ADDENDUM NO. 2

HONOKAI'A NON-POTABLE WATER SYSTEM

IFB NO.: IFB-19-HHL-006

Tank Liner – Might need to be replaced

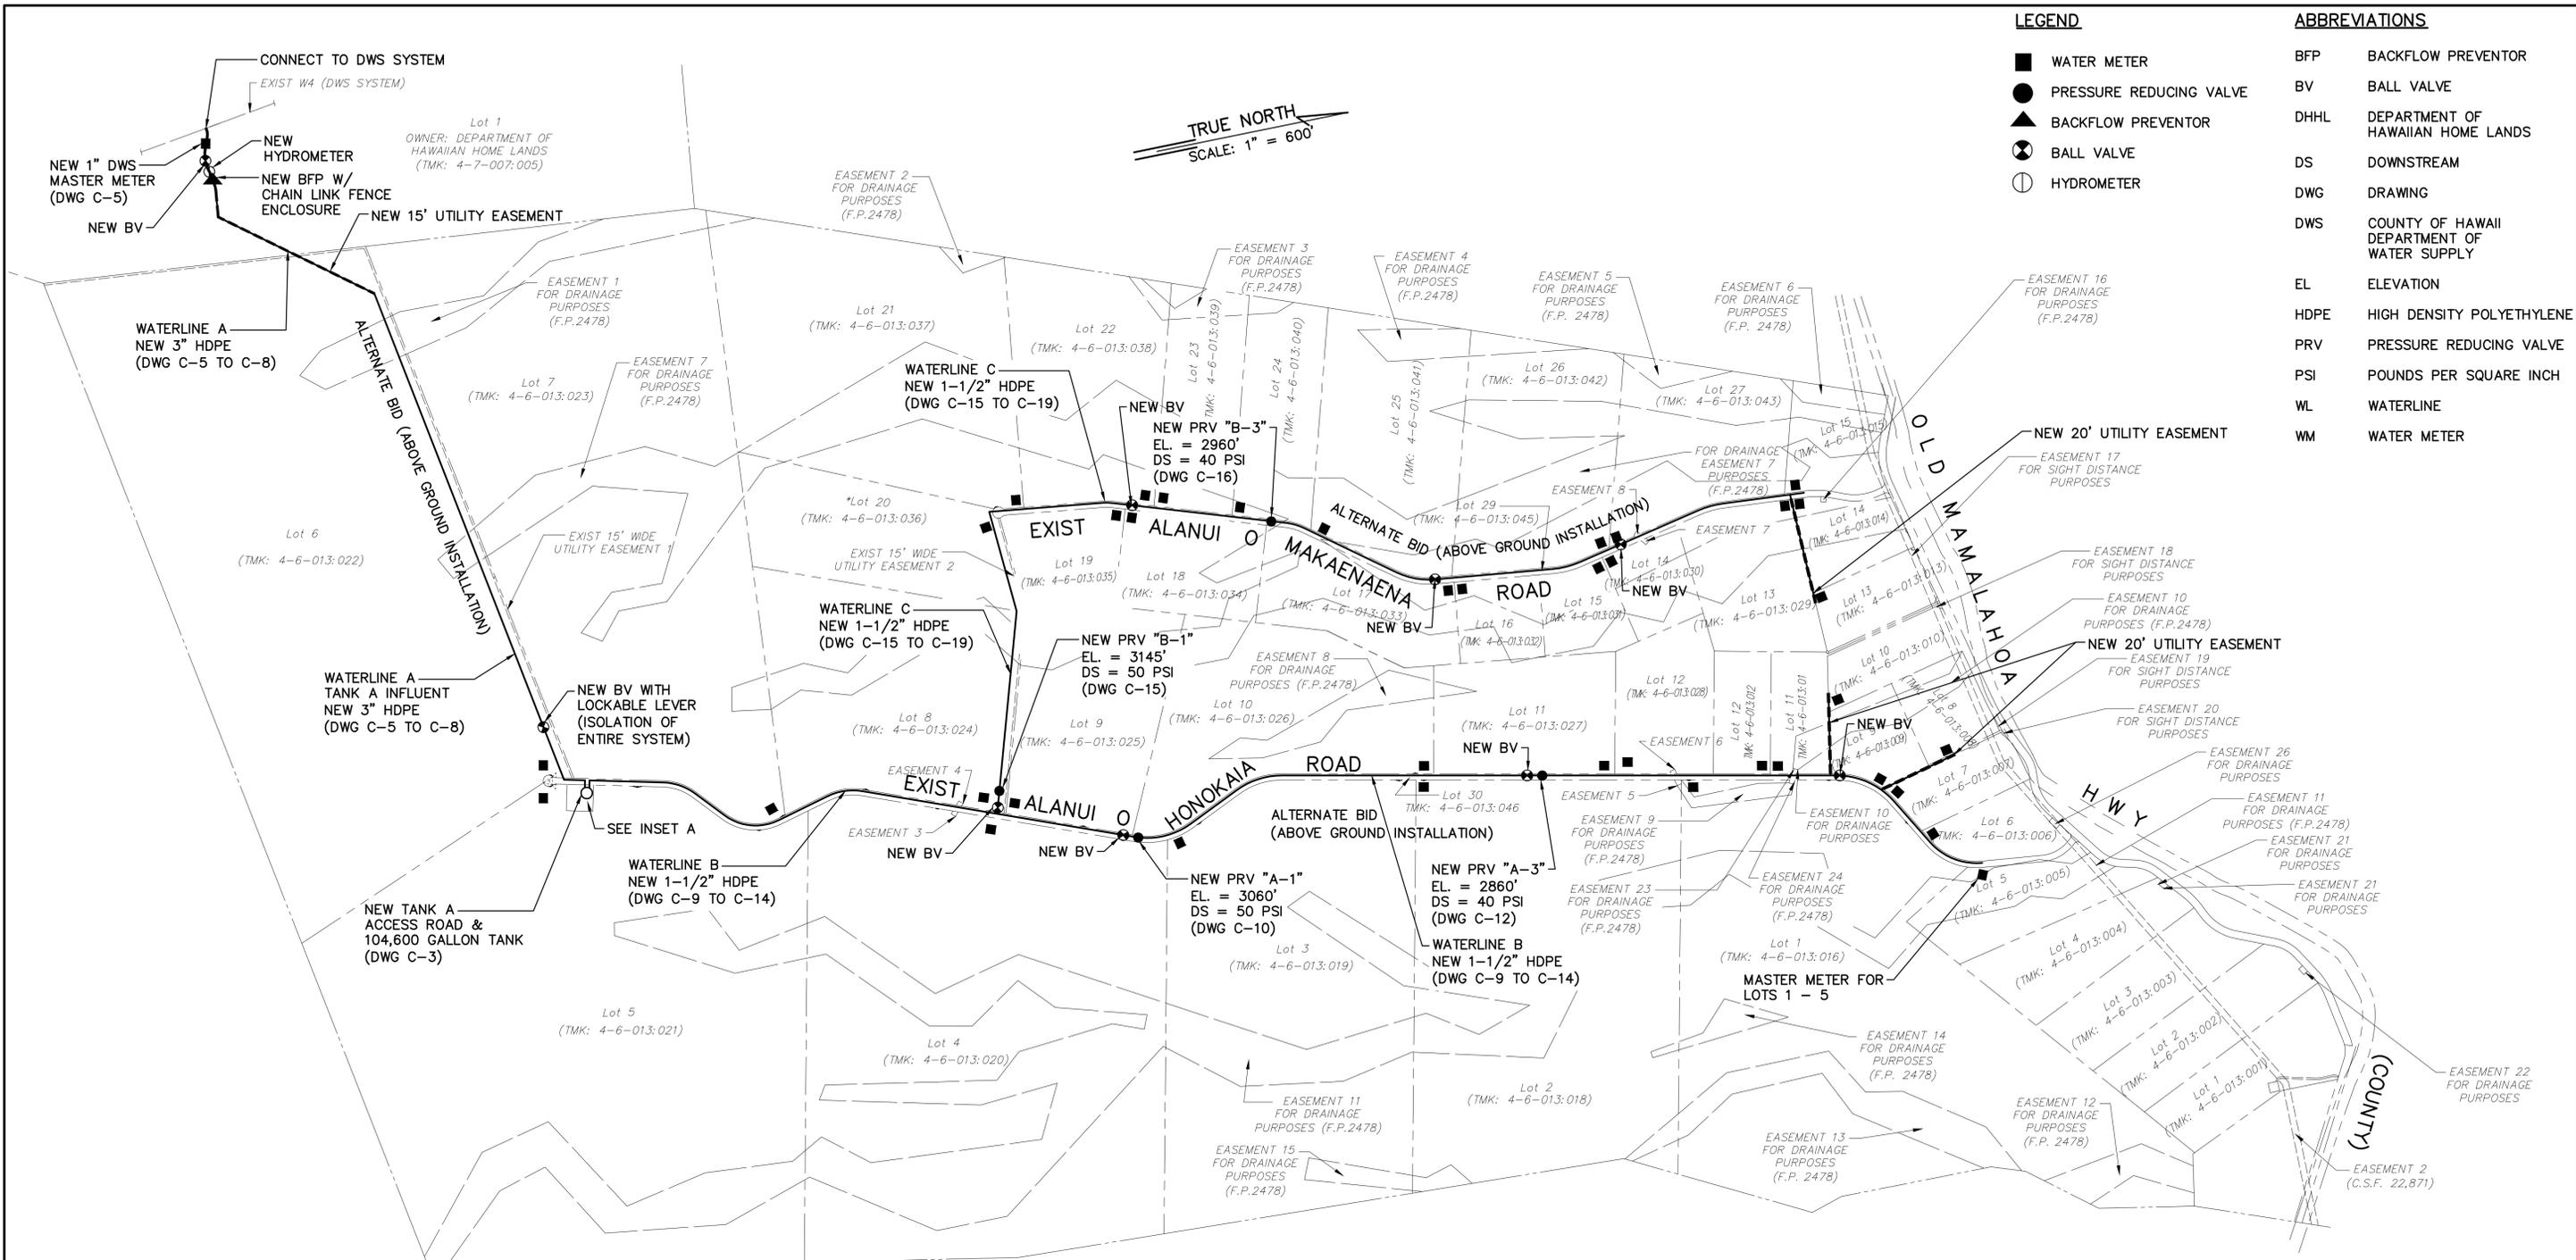
Is there an inventory of the tank?

- A basic inventory is attached. However, the Contractor shall inventory the existing tank components and provide a list of “missing” or “not usable” parts prior to work on the Tank. At a minimum, liner needs to be replaced and new nuts and bolts should be used.

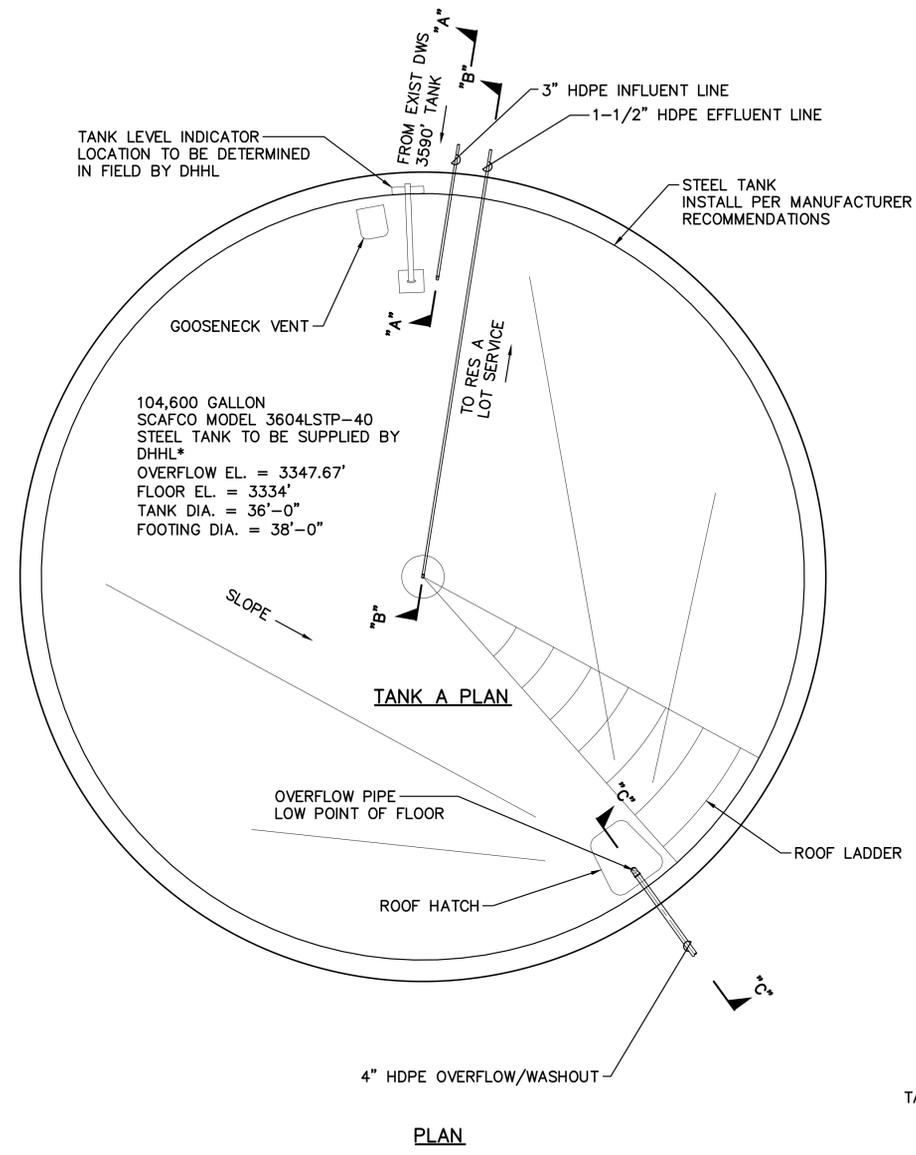
Please provide a detail for ARV and PRV Protection from pigs and cattle.

- See Detail 9/C-21, above ground installation, to the right of the ARV detail. The Contractor may propose alternative options for protection subject to approval by DHHL. All PRVs shall be buried.

NOTE: ABOVE GROUND ARVS SHALL BE PROTECTED BY AN ENCLOSURE TO PREVENT DAMAGE FROM ROAMING CATTLE. THE CONTRACTOR MAY PROPOSE ALTERNATIVE OPTIONS FOR PROTECTION SUBJECT TO APPROVAL FROM THE DEPARTMENT.

1 TANK DETAILS
 C-23 NOT TO SCALE

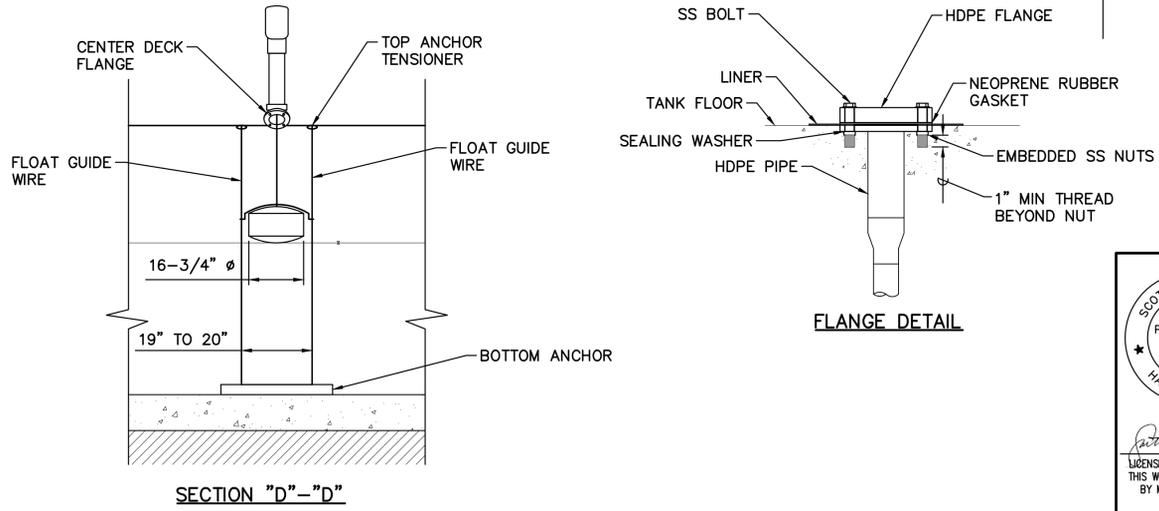
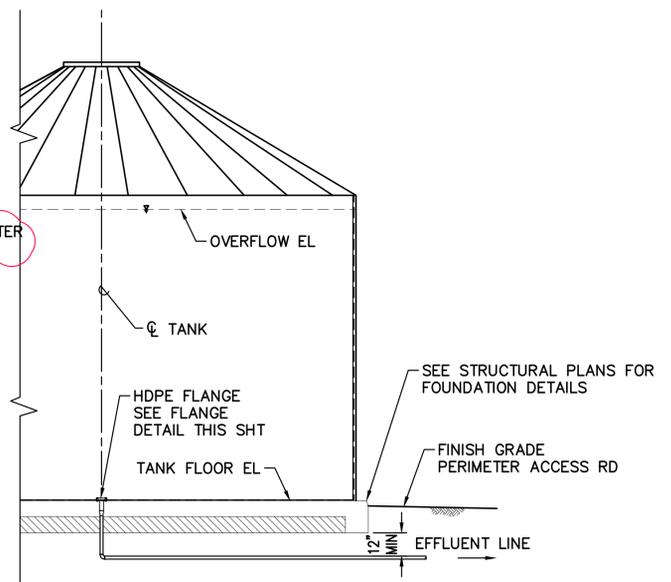
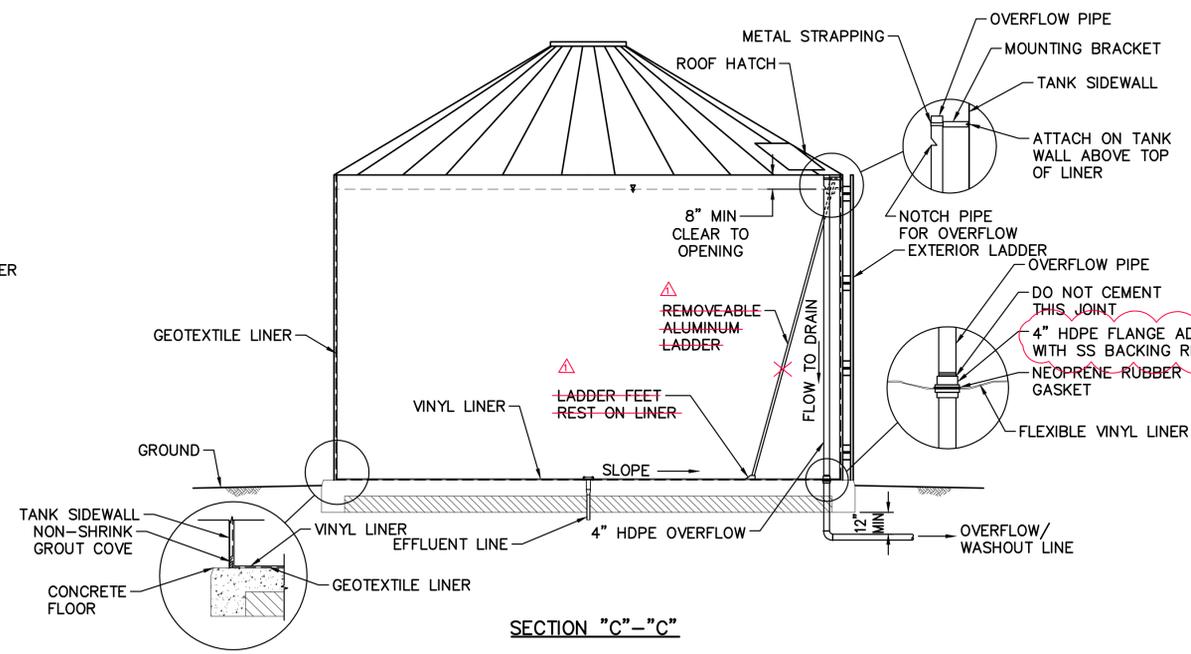
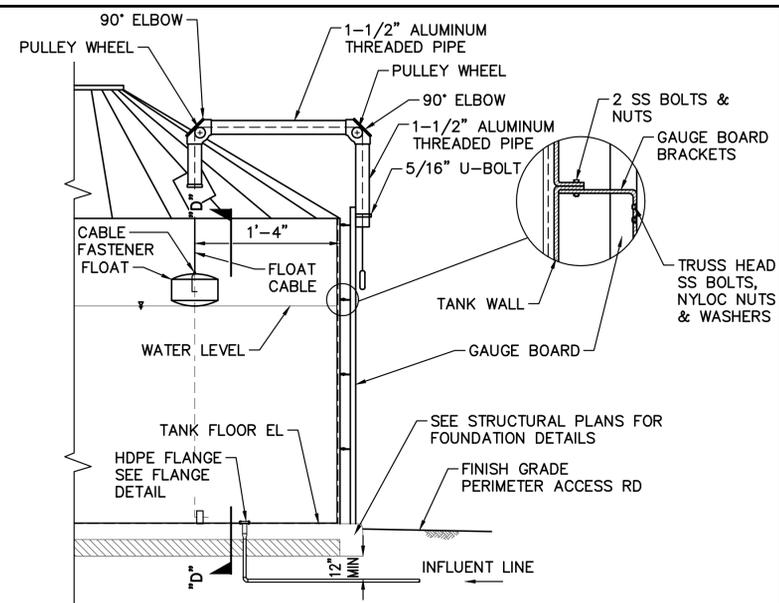
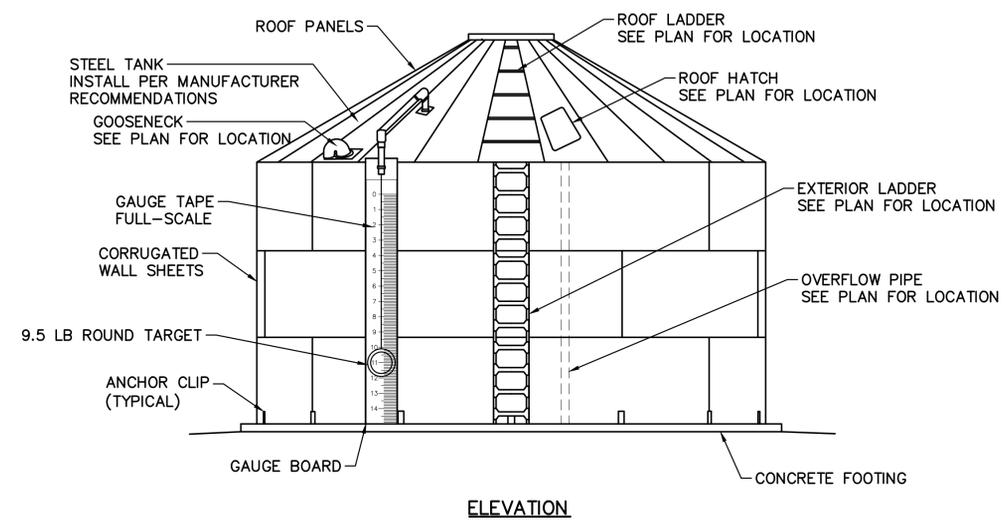
Drawing: C-23 – Section C-C Interior Ladder: Whereas the space inside the active tank is considered “permit required confined space” and the presence of an interior ladder may encourage entry of untrained and uncertified individuals. This creates an unnecessary drowning hazard and a liability for the DHHL. It is recommended to delete the interior ladder.

- Remove interior ladder.

REVISION DATE	DESCRIPTION	MADE BY	APPROVED
12/11/18	REMOVE INTERIOR LADDER, UPDATED CALLOUT	A&A
